CITY OF ALBUQUERQUE

PLANNING DEPARTMENT – Development Review Services

**RE: Main Event, Albuquerque Carpenters Training Center (File: G16-D149)
4040 Pan American Freeway NE 87107
Interim Grading Plan and Drainage Plan, Engineer's Stamp Date 5-27-2015**

DRAWN BY
BJF
DATE
05/25/16
2015015-GRB-INTERIM
SHEET #
C6A
JOB #
2015015

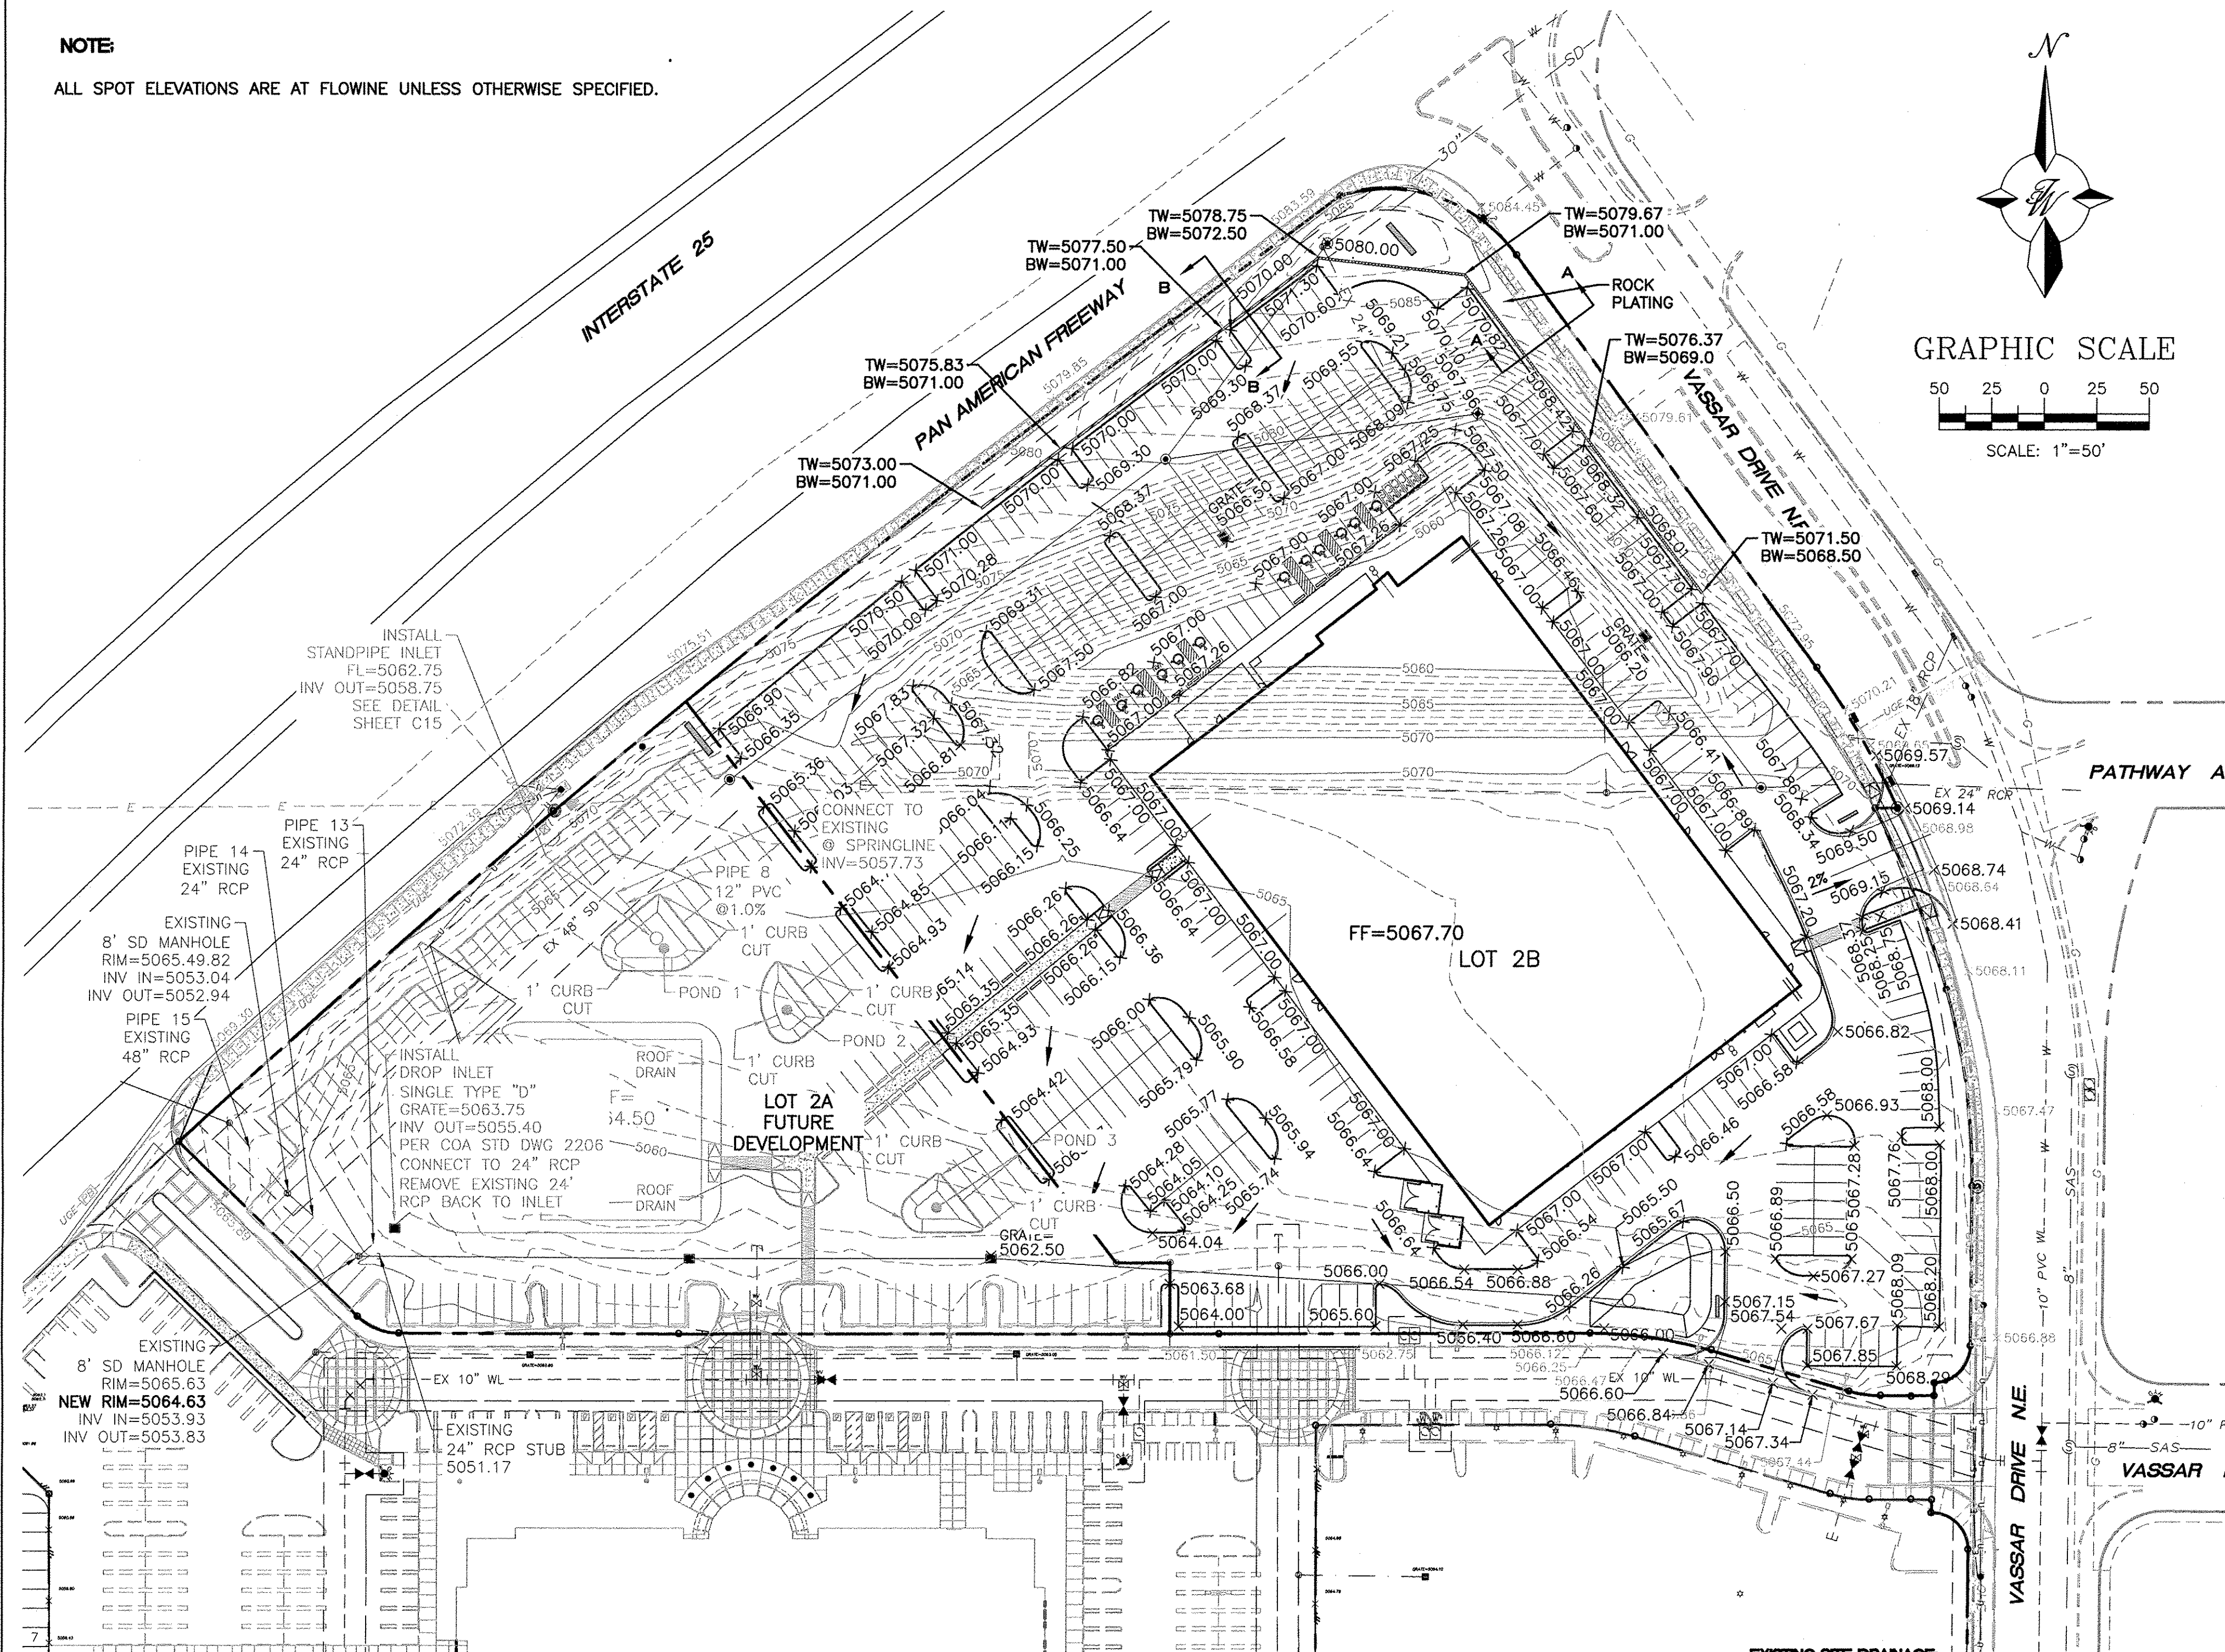
While this interim plan did not show how the interim drainage was to function, this is the plan used for the Engineer's Certification. For this reason, this interim plan is being approved.

Based upon the information provided in your submittal received 5-27-14, the above referenced plan is approved for Building Permit based on the following comments:
